South Texas Project
Units 1 & 2
Docket Nos. STN 50-498, STN 50-499
NRC Question Responses

620.0 HUMAN FACTORS ENGINEERING BRANCH

620.2 Provide the following information and clarification regarding your summary report for the Detailed Control Room Design Review (DCRDR) submitted April 12, 1984:

Figure 620.2-2

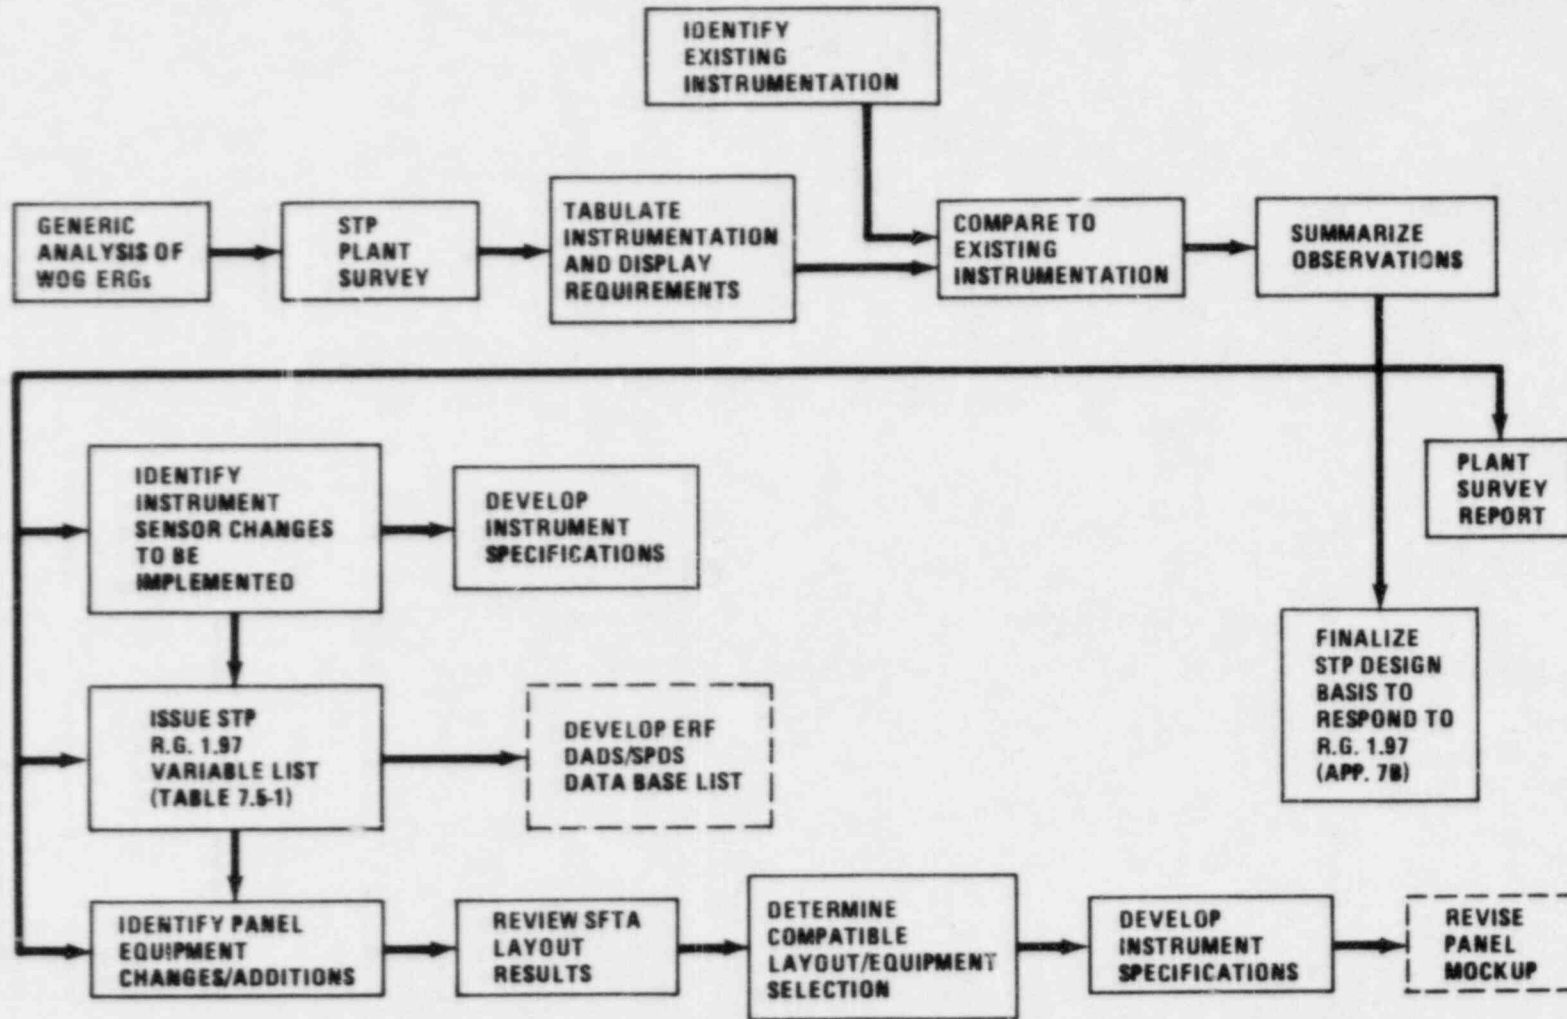
- a. Your systems function and task analysis (SFTA) was performed through document reviews, briefings, and walk-throughs on the mock-up and updated using the revised mock-up as reported in the SFTA Validation Report. Because the SFTA was not based on upgraded emergency operating procedures (EOPs) required by Supplement 1 to NUREG-0737, and because EOP's are not typically available at early stages of design and construction, but should be available prior to licensing, please confirm, after EOPs are finalized, that information and control function needs have been adequately identified and are satisfied by available instrumentation and controls.

- b. Verify that an objective comparison of independently determined display and control requirements, as determined by function and task analyses has been made with the control room inventory to identify missing controls and displays as required in Supplement 1 to NUREG-0737, and summarize the results of this comparison.

- c. Substantiate that an objective, independent determination of the operator information and control needs for each operator task has been made before instrument and control specifications are developed.

In parallel with the STP CRDR SFTA efforts, STP performed an analysis to address post accident monitoring requirements to respond to Regulatory Guide 1.97. A flow chart of the STP Regulatory Guide 1.97 implementation process is shown in Figure 620.2-2. This was accomplished by performing a task analysis based on the WOG ERGs to identify variables necessary for implementation of the guidelines. This analysis was applied to the STP specific design through a plant survey of the STP design documents. The STP specific analysis is summarized in STP FSAR Appendix 7B. The analysis itself identified, in addition to the variables necessary for implementation of the ERGs, variable display requirements including range, accuracy, qualification, redundancy, recording needs, and operator task utilization. These requirements were compared to existing STP instrumentation to determine required design changes. These changes were incorporated in the revised main control panel mock-up and were utilized in the CRDR SFTA validation. This instrumentation is summarized in FSAR Table 7.5-1.

- a. The development of the South Texas Project Electric Generating Station (STPEGS) EOPS are based on Revision 1 of the Westinghouse Owners Group (WOG) Emergency Response Guidelines (ERGs). During the conversion process the instrumentation and control requirements of the ERGs are compared with the Regulatory Guide 1.97 equipment to develop both the normal and alternate indications available to the operators. Prior to final approval of the STPEGS EOPs, they will be placed through a verification and validation program as specified by Supplement 1 to NUREG-0737. This program will be described in detail in the Procedure Generation Package scheduled for submission in June of 1985. This program will confirm that the instrumentation and control function needs have been adequately identified and are satisfied.

The Regulatory Guide 1.97 implementation process included a comparison of the display or monitoring requirements, as defined by the STP design basis to respond to Regulatory Guide 1.97, to the main control panel equipment. The monitoring requirements are stated in terms of range, accuracy, and Regulatory Guide 1.97 category which in turn defines instrumentation qualification, redundancy, and display and/or recording requirements. This comparison was performed and documented in an STP Regulatory Guide 1.97 plant survey.
